AMENDMENTS TO THE DRAWINGS

REMARKS

FIG. 8

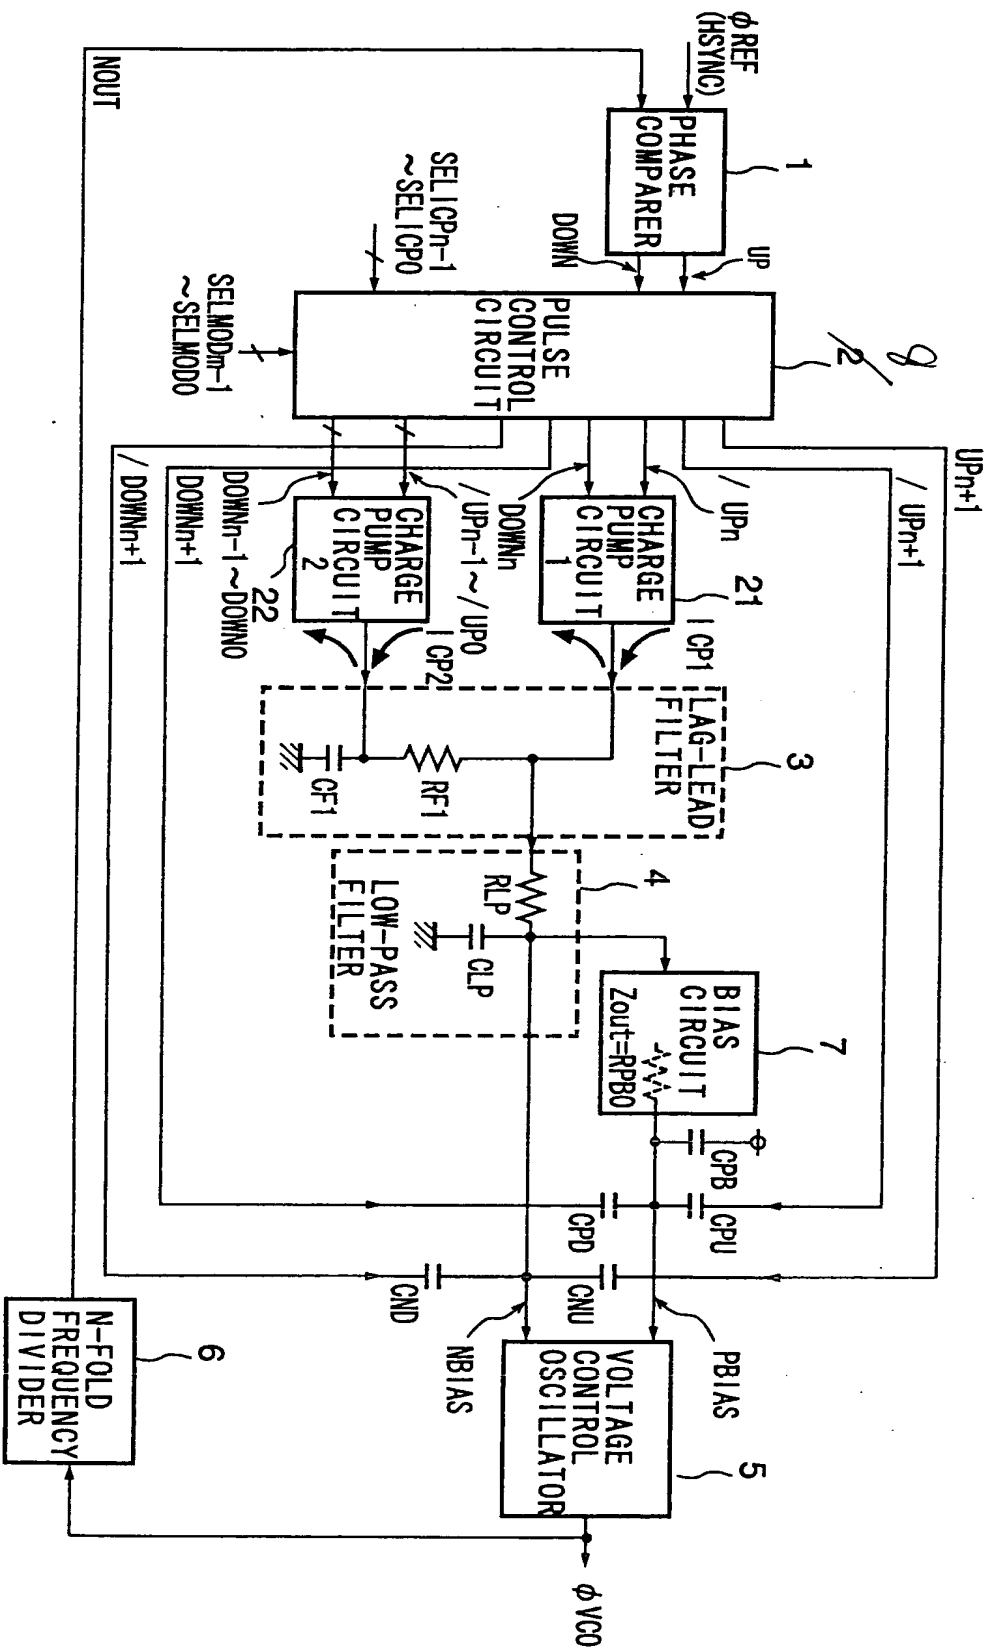
Sheet 1 includes Fig. 8 – Please amend reference numeral -- 2 -- to “8” for the pulse control circuit.

Changes are made to the drawings as shown on the attached sheets. In particular, Figs. 11 to 16 are labeled as PRIOR ART in accordance with the discussions at pages 1 to 30 of the specification as filed. In addition, reference numeral 2 has been changed to 8 for the pulse control circuit in Fig. 8

FIG. 11 *Prior Art*

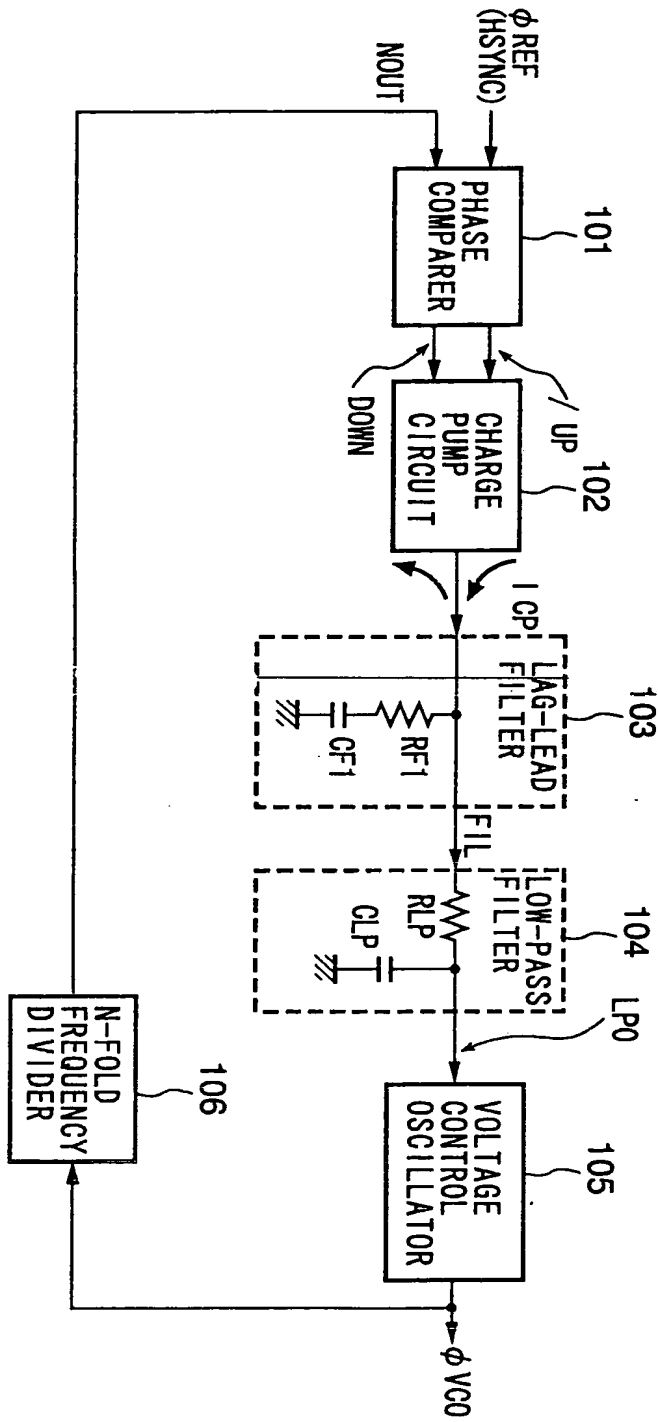
Sheet 2 includes Fig. 11 – Please label this figure as “Prior Art”.

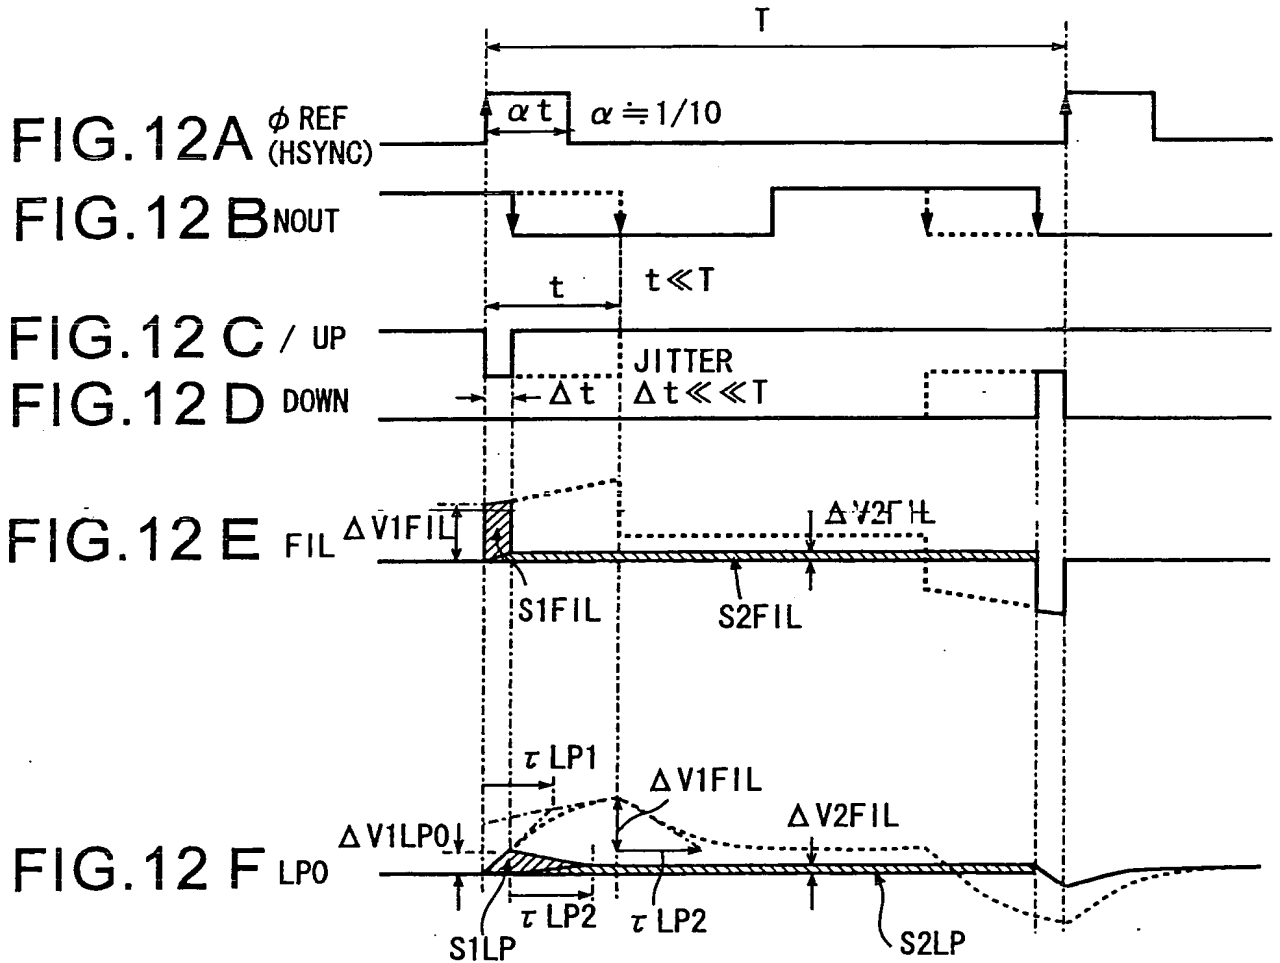
Sheet 3 includes Fig. 12 – Please label this figure as “Prior Art”.

FIG. 13 *Prior Art*

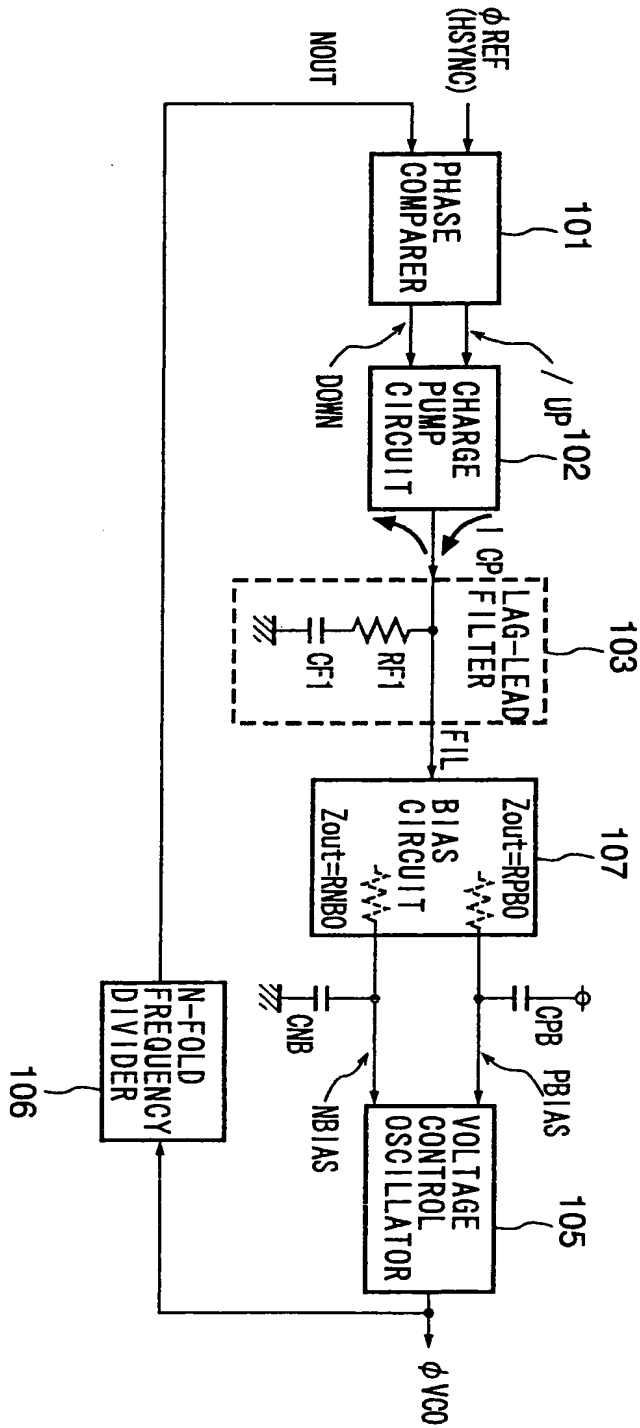
Sheet 4 includes Fig. 13 – Please label this figure as “Prior Art”.

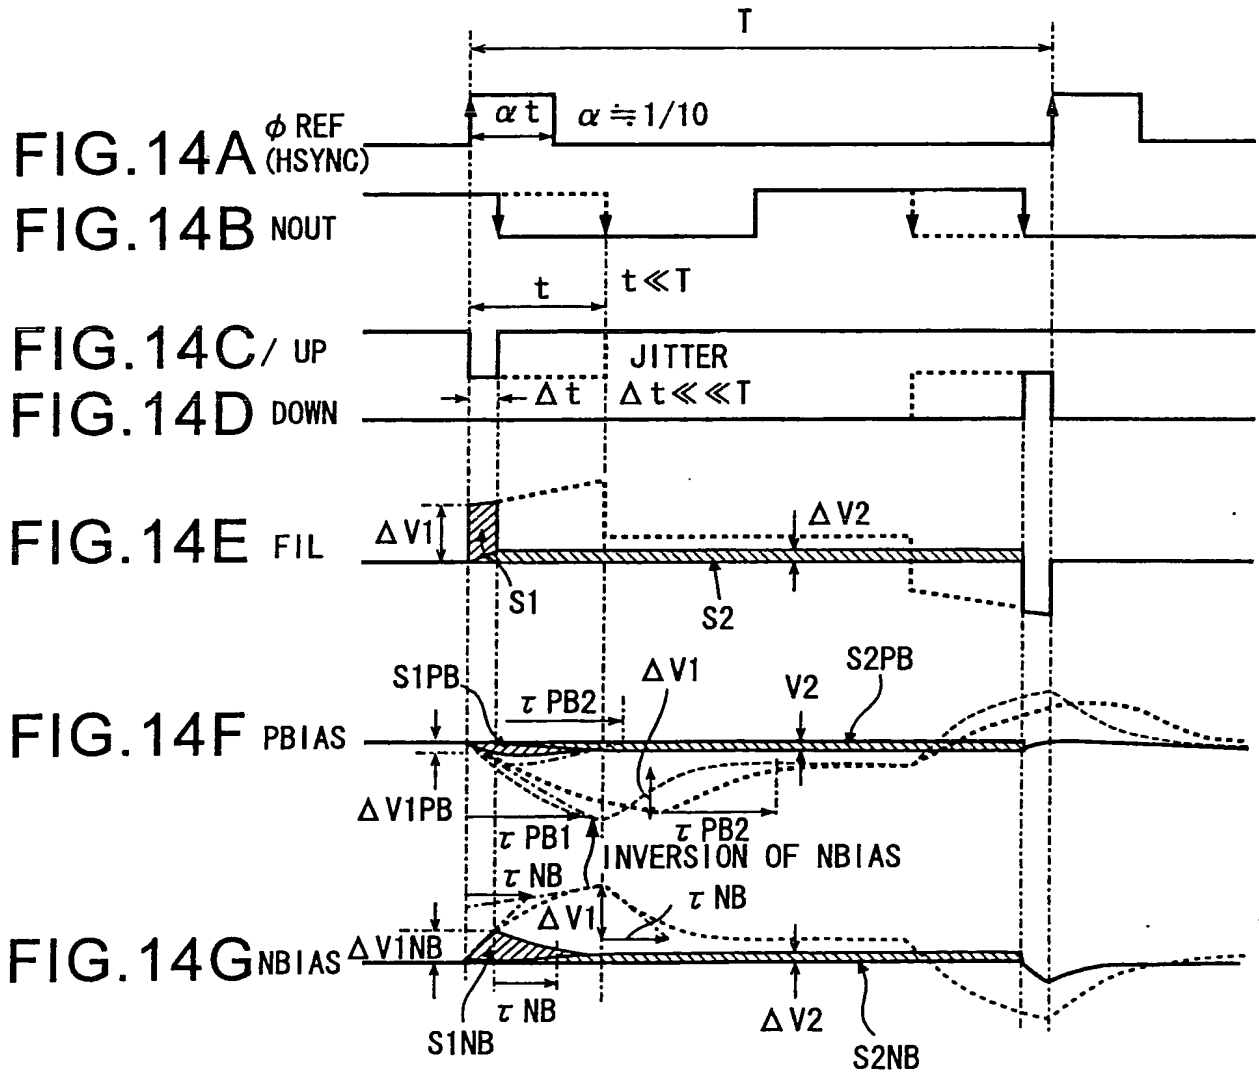
Sheet 5 includes Fig. 14 – Please label this figure as “Prior Art”.
